# SUPPLEMENTAL REPORT TO THE HEARING OFFICER

PROJECT NUMBER: 2020-000089-(3)

Minor Coastal Development Permit ("Minor CDP") PERMIT NUMBER(S):

This agenda item is a request for removal of unpermitted structures and the retroactive approval of a swimming pool, a footbridge, and a driveway spur, which are all associated with an existing single-family residence. Encroachment into the protected zones of six oak trees would occur during the removal of unpermitted structures, while the driveway and swimming pool encroach into the protected zones of nine oak trees (15 encroachments total).

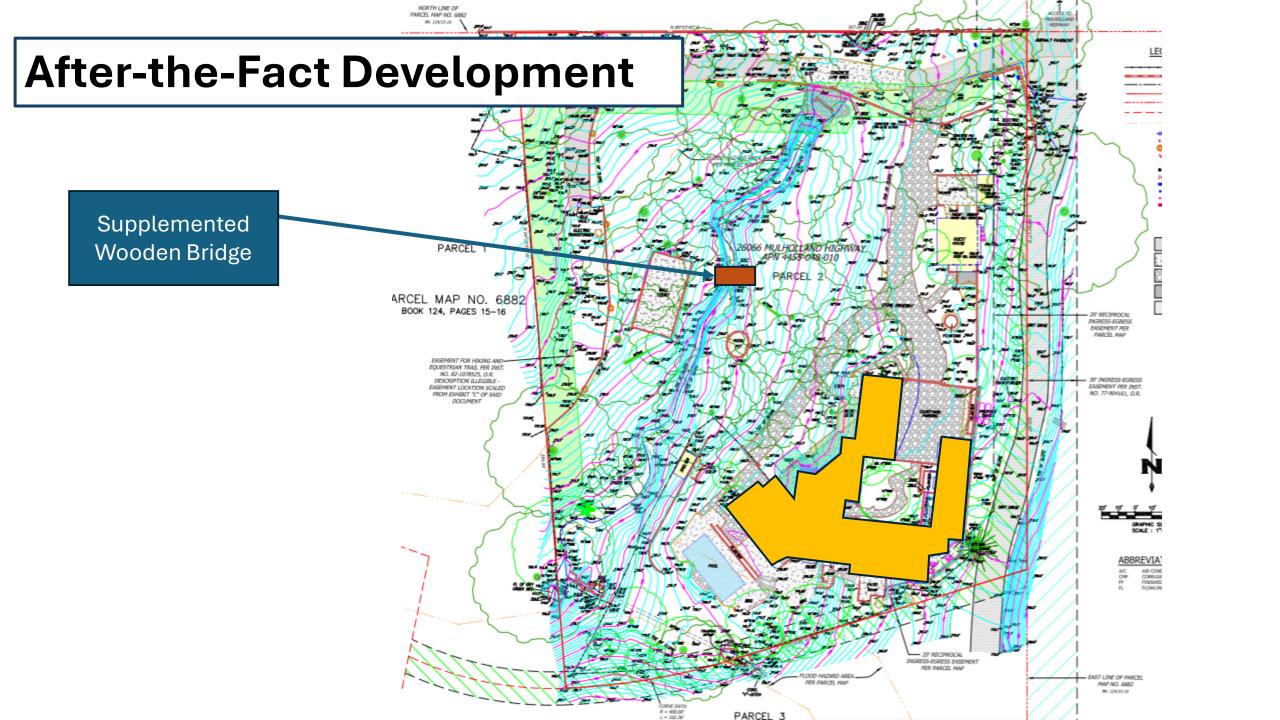
I am writing in regard to the above-mentioned property for Project No. PRJ2020-000089-(3) and Minor Coastal Development Permit No. RPPL2020006422. We reviewed the staff report findings and do not agree in the removal of the footbridge as indicated on page 8 of 11:

The ERB recommended that the existing footbridge remain in place to prevent potential erosion of the stream bank. However, Staff recommends that the footbridge be removed, as it is not an allowable use within H1 Habitat. Therefore, prior to final approval for the Project, the applicant would be required to submit a removal and restoration plan for the bridge that must be reviewed and approved by the Staff Biologist.

We have provided the documentation from the ERB on September 19<sup>th</sup>, 2022 stating that the footbridge is small and exert a negligible effect on the woodland. Further, the ERB stated that, "the bridge is above the Ordinary High Water Mark of the stream and does not appear to be impairing the hydrology of the stream, which has been deeply incised, presumably due to upstream hydrological modifications related to the street drainage on and immediately adjacent to the north end of the subject property. Removal of the bridge would introduce disturbance to an evidently stable bank, potentially creating greater unforeseen impacts, and staff recommends leaving the bridge in place."

We would appreciate it if we could retain the footbridge as located and no further removal or associated removal to the footbridge be required. Thank you for your time and consideration. Please let me know if you have any questions or concerns.

Old footbridge was present at the time of obtaining building permits for the SFR

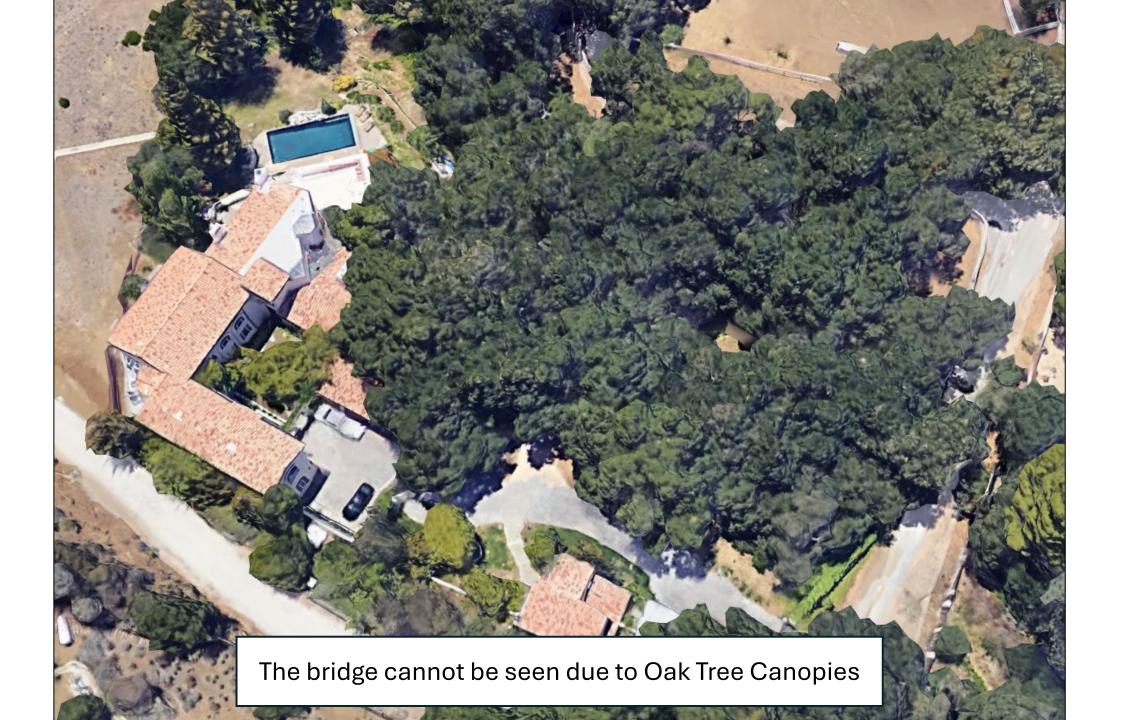
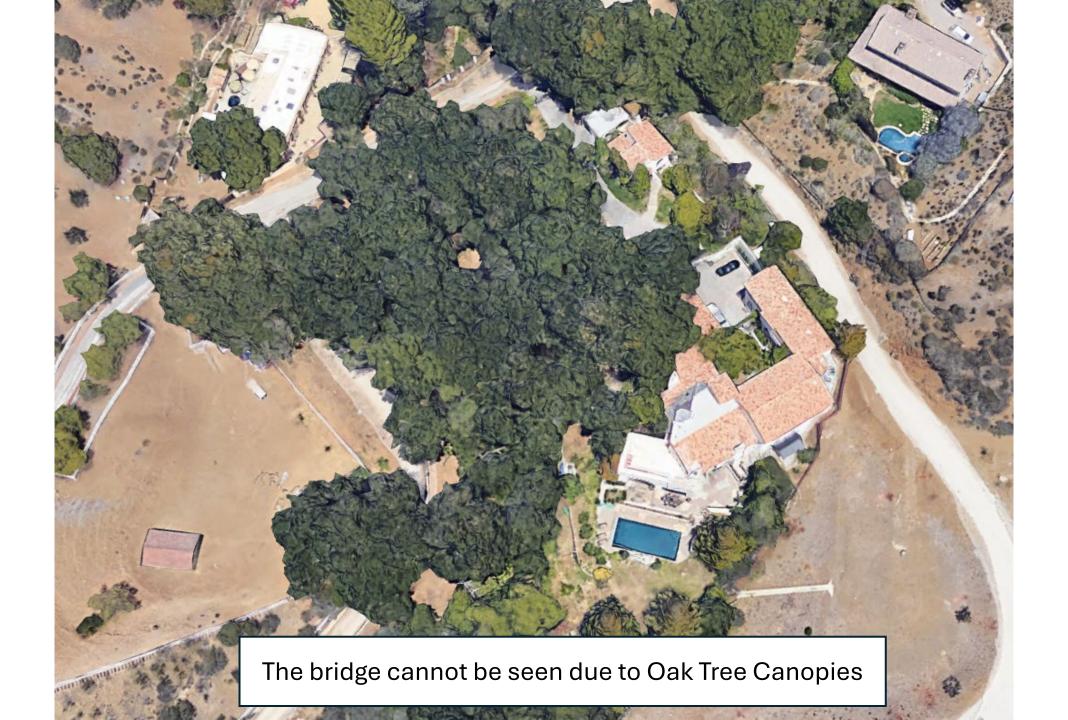
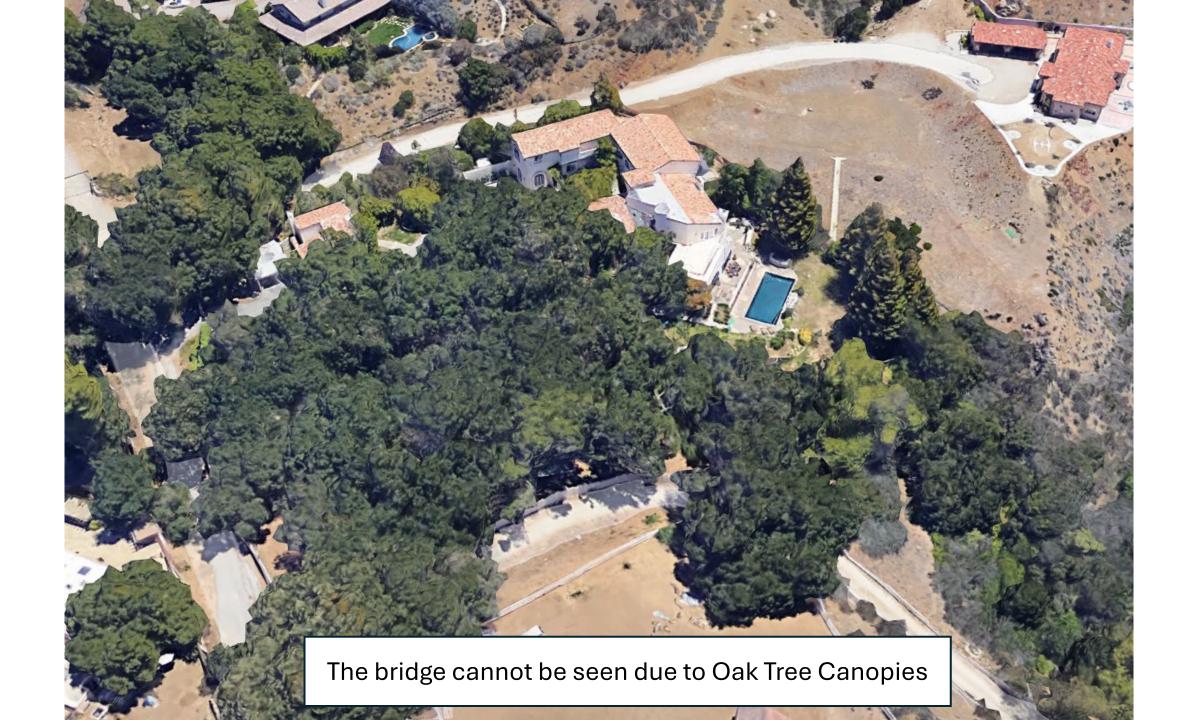
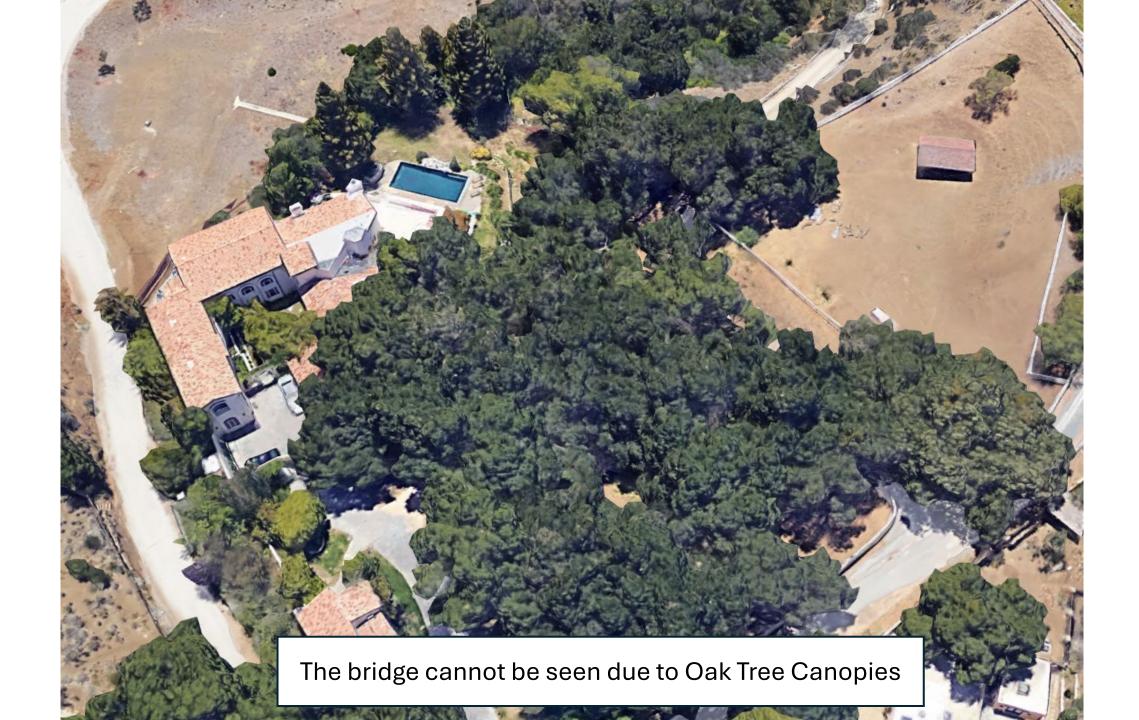
The wooden footbridge and cement rock pond are both small and exert a negligible effect on the woodland. The pond is small enough that its total impact on the protected zone of trees is minor. It is proposed to be drained and the footprint restored to resemble existing oak woodland.

The bridge is above the Ordinary High Water Mark of the stream and does not appear to be impairing the hydrology of the stream, which has been deeply incised, presumably due to upstream hydrological modifications related to the street drainage on and immediately adjacent to the north end of the subject property. Removal of the bridge would introduce disturbance to an evidently stable bank, potentially creating greater unforeseen impacts, and staff recommends leaving the bridge in place.
